SUBJECT: FOLLOWUP QUESTIONS REGARDING REACTOR VESSEL INTEGRITY DURING SEVERE
ACCIDENT CORE MELTS

Docket No. 52-003

INEL Comments and Questions about DOE/ID-10460

Figure 2. Comparison of correlations for predicting upward heat transfer.

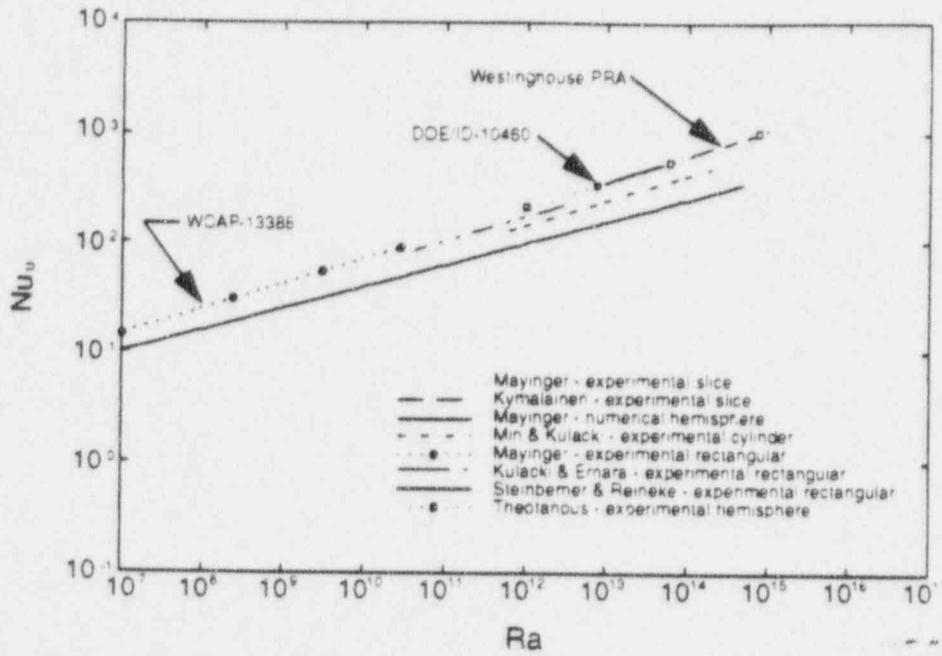
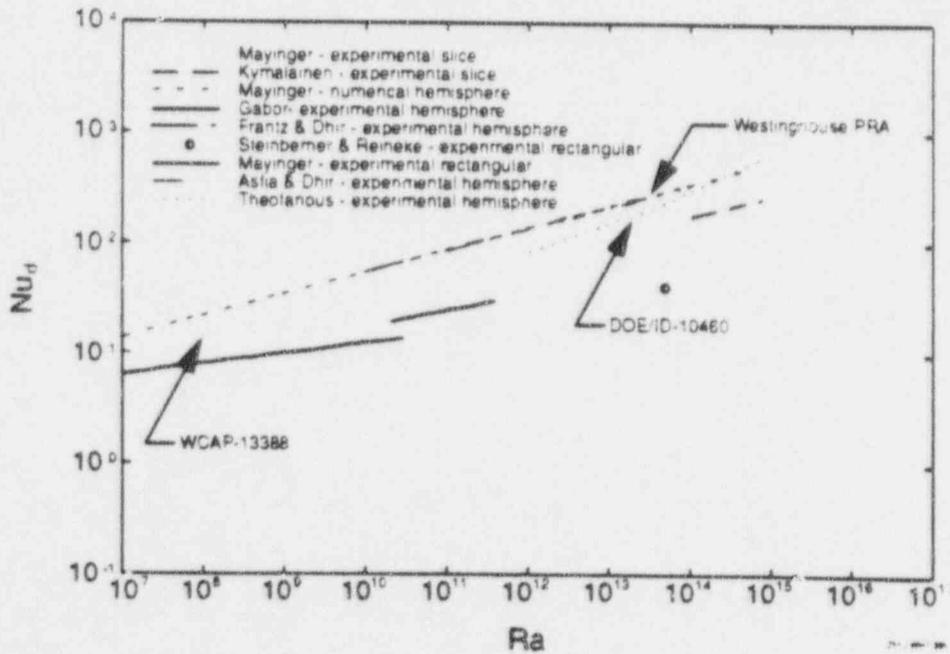
- 480.442 Figures 1 and 2 compare several natural convection heat transfer correlations developed from various experimental and analytical studies. In these figures, correlations are plotted over the range of Rayleigh numbers for which they were developed. As shown in these figures, there is considerable scatter between various correlations. Comparing the experimentally-developed, Kymalainen and Theofanous correlations, one can see that the ratio of upward to downward heat transfer is lower for the Theofanous data in the higher Rayleigh number range. Thus, an analyses assuming the Theofanous correlations (based on mini-ACOPO data) will predict less heat being transferred to the metal layer above the ceramic debris and reduced heat fluxes from the metal layer to the wall. This trend is demonstrated in Figure 7.15, which investigates a sensitivity in which the Mayinger correlation was substituted for the mini-ACOPO Theofanous correlation (the Mayinger correlation is lower than the Theofanous correlation for pool Rayleigh numbers of 10^{15}). Larger differences exist between the Theofanous and Kymalainen correlations than the Mayinger and Theofanous correlation for pool Rayleigh numbers at 10^{15} . In their response to Dr. Schmidt, the authors state that these differences are due to the shape of the lower boundary. However, this emphasis on geometry yields the author's data as the only data applicable to these tests. Furthermore, mini-ACOPO data do not agree with other hemispherical correlations at low Rayleigh numbers. Please perform a sensitivity study based on the Kymalainen data.

Figure 3. Comparison of area corrected localized Mayinger data.

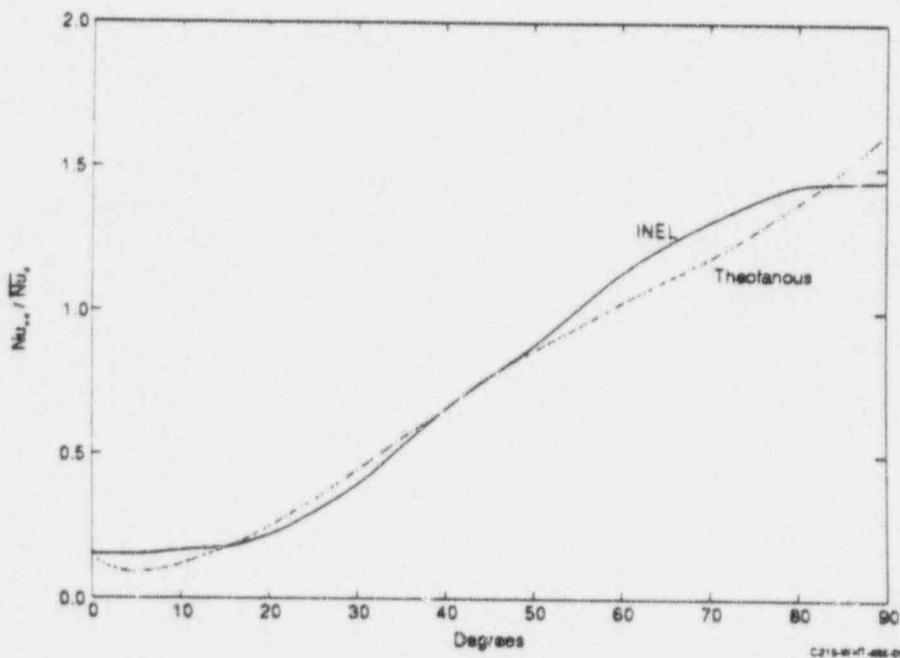
Please clarify how this equation was applied to obtain the Figure 5.8 Mayinger curve. Assuming the Mayinger (1985) curve is based on information from Mayinger (1975)^a and Jahn and Reineke (1974), INEL obtained the curve shown in Figure 3. Note that the peak local value (at 90 degrees) is lower than either the mini-ACOPO curve or the Mayinger (1985) curve shown in Figure 5.8. Please discuss the equations used to obtain the Figure 5.8 Mayinger (1985) curve and include the Kymalainen COPO local values in Figure 5.8.

Figure 4. Impact of boiling on heat transfer from a molten pool.

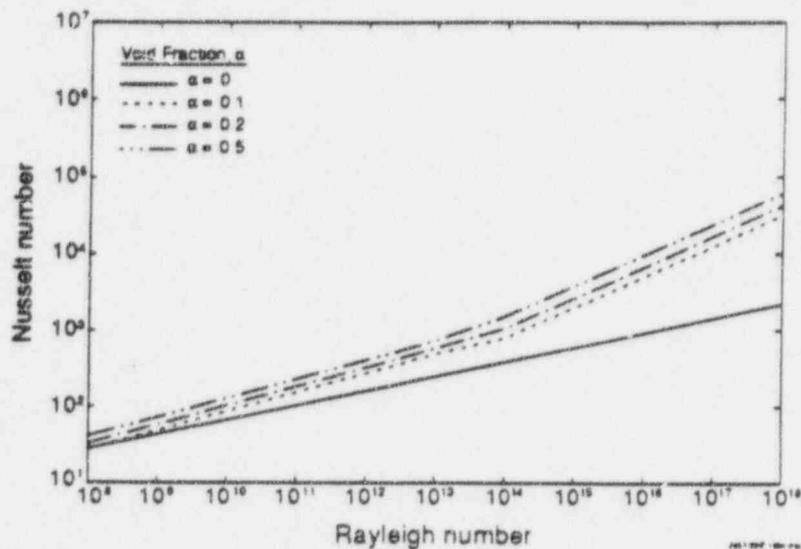
- Identify the two-dimensional heat transfer model used for these calculations.
- Clarify how the vessel dimensions and heat fluxes shown in Figure 5.15 were derived.
- Clarify the impact of applying results from a vertical, flat plate analyses to a structure that is angled (the Figure 5.15 diagram should be at least 70 degrees as indicated in Figure 4.8).
- Explain why heat fluxes are higher within the unmelted vessel steel in Figure 5.16 (heat fluxes of nearly 1600 kW/m² are predicted within the vessel, but not on the surface).

Figure 5. Comparison of correlations for predicting upward heat transfer from the metal layer.

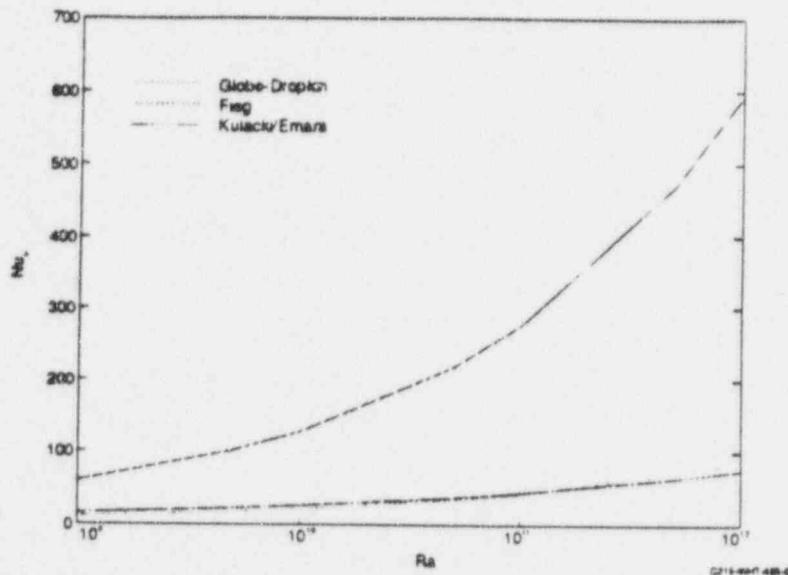
Correlations developed from Fieg and Kulacki, et al. for upward heat transfer are compared with the Globe-Dropkin correlation in Figure 5. As shown in this figure, the Globe-Dropkin correlation applied in Reference 1 predicts higher upward heat losses from the metal layer. Assess the impact on results if the Fieg and Kulacki data were used instead of the Globe-Dropkin correlation.

Figure 6. Possible CHF-limited vessel wall thicknesses (Upper bound assumptions correspond to maximum vessel melting temperature and reduced CHF values; Lower bound assumptions correspond to minimum vessel melting temperatures and maximum CHF values).

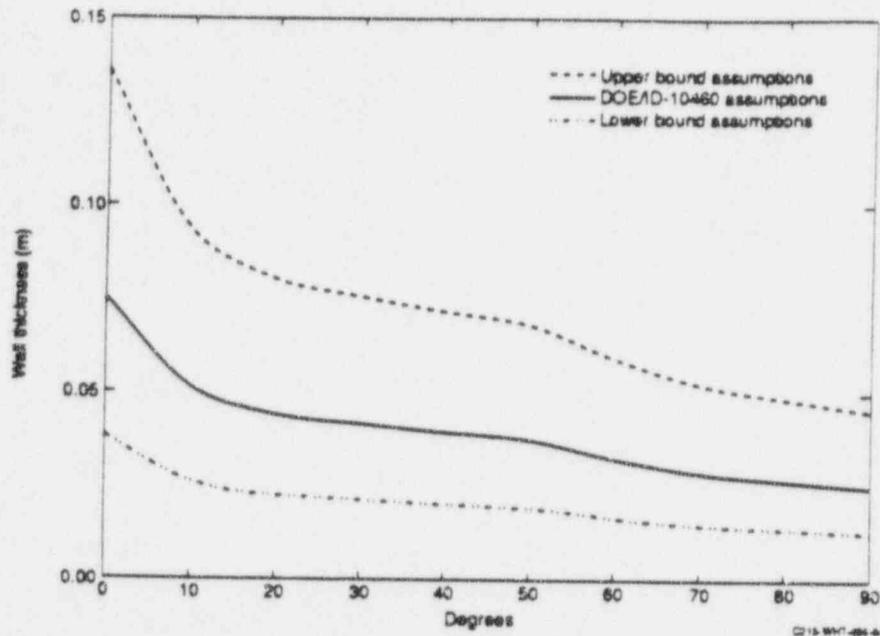
For example, it appears that Figure 4.1 was obtained by using the best estimate values for critical heat flux (Figure 3.3), vessel wall thermal conductivity (32.0 W/K-m per Table 7.1), and iron-zirconium liquidus temperature (Figure 6.1). If one considers the uncertainties in the vessel thermal conductivity ($\pm 10\%$ according to Appendix L) and the iron-zirconium liquidus temperature (variations in the mole fraction of zirconium may lead to liquidus temperatures between 1201 and 1948 K), the CHF-limited wall thickness could be as small as 1.5 cm (compared to the 2.5 cm shown at 90 degrees in Figure 4.1). If one were to consider the uncertainties estimated by others for similar experiments ($\pm 20\%$),⁵ the CHF-limited wall thickness would be reduced even further as shown in Figure 6. As discussed in the structural analyses comments, this thickness (and other uncertainties related to the structural analyses presented in Section 4) reduces the robustness of Section 4 conclusions, and the finite element calculations should be revised using an appropriate vessel wall thickness

dreds of degrees. However, Section 4 only indicates that one temperature was considered. As discussed above, if the range of possible temperatures were considered along with other uncertainties in predicting the wall thickness, the range of wall thicknesses shown in Figure 6 are possible. Please revise this analysis assuming an appropriate minimum wall thickness.

Figure 7. Possible endstates that may be more challenging than the Reference 1 endstate.

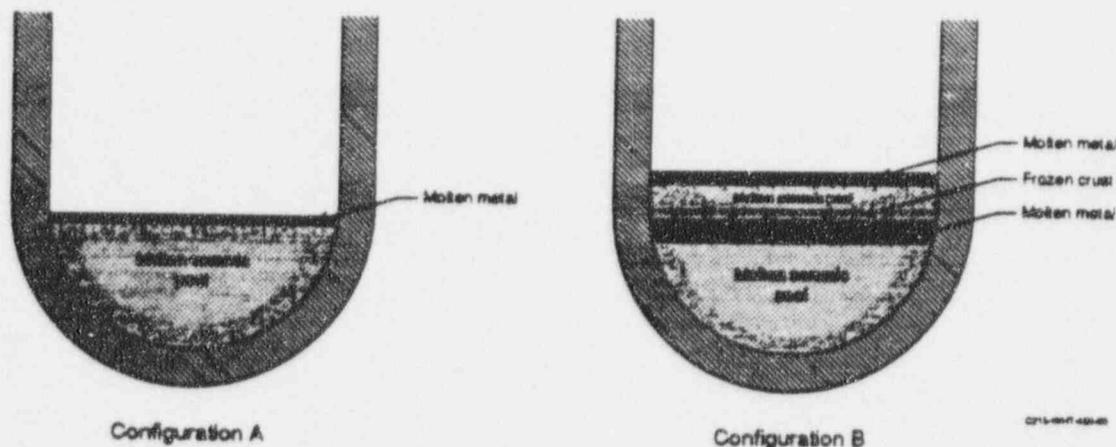
- 480.455 As noted by Levy and a number of the reviewers, the assumed end state condition shown in Figure 2.2 is not necessarily the bounding or even most plausible configuration for the stratification of frozen and molten material. Figure 7 illustrates several possible asymmetric, idealized configurations that may be more challenging than the one assumed in Reference 1.

- Configuration A corresponds to results from SCDAP/RELAP5 calculations for a similar scenario. (This calculation is not yet complete in that a further assessment of lower head heat transfer and the potential for additional relocation of steel is still to be completed). The configuration is characterized by a large oxidic pool (~85% of the core inventory) with a small metallic component (~5600 kg of unoxidized Zr and ~3400 kg of stainless steel). This configuration developed primarily as a result of localized relocations through the reflector sidewall. The stainless steel component accumulated from the melting of gray rods and the addition of lower plenum structures that melted as a result of being submerged by the debris. Calculations suggest that this configuration could persist for a period of time necessary to completely boil water in the lower head and then melt portions of the lower core plate. During this period, the metallic layer of ~10 cm would remain well below the threshold of 15 cm, which was given as the thickness necessary to insure vessel integrity under 'focused' heat loads. Furthermore, asymmetries *could* be expected in the core region as a result of the break location and the conditions that could develop in the vicinity of other major vessel penetrations (e.g., accumulator flow lines, core makeup line). These asymmetries that could significantly reduce steel melting and, ultimately, the thickness of the 'focusing' layer. In the main results, please assess the impact of a thin-metallic layer on lower head integrity, as a result of potential relocation scenarios and as a result of acknowledging asymmetries in core melt progression.

In Configuration B, a second pour would relocate onto the core plate forming a crust above the core plate. Any subsequent pours result in a second molten pool with a thin metal layer above it. As discussed above, multiple pours are possible because there are non-axisymmetric heat transfer boundaries. The core plate would be heated from below by the molten pool and above by the overlying crust. Metal in the core plate would become molten and eventually superheated, possibly resulting in a more severe heat load to the vessel than that postulated in the report. Hence, the idealized configuration shown in Figure 2.2 is only one of many plausible configurations. As discussed in Appendix O, factors such as the "random nature of boiling crisis (as found in ULPU), natural asymmetries in the thermal loading," etc. will make it highly unlikely that the actual endstate in the lower head is axisymmetric. Hence, there are a number of additional scenarios that could have been considered that may be more plausible than the configuration presented in Figure 2.2. As Dr. Levy noted, if the molten stainless steel becomes trapped below a crust of ceramic material, the molten stainless steel must either continue to heatup above the melting point of the ceramic crust or mechanically break through the crust to migrate to the top of the ceramic layers. In the event that molten steel becomes trapped below a crust of ceramic material, please assess the thermal loads on the vessel and the margin to vessel failure in the steel region.
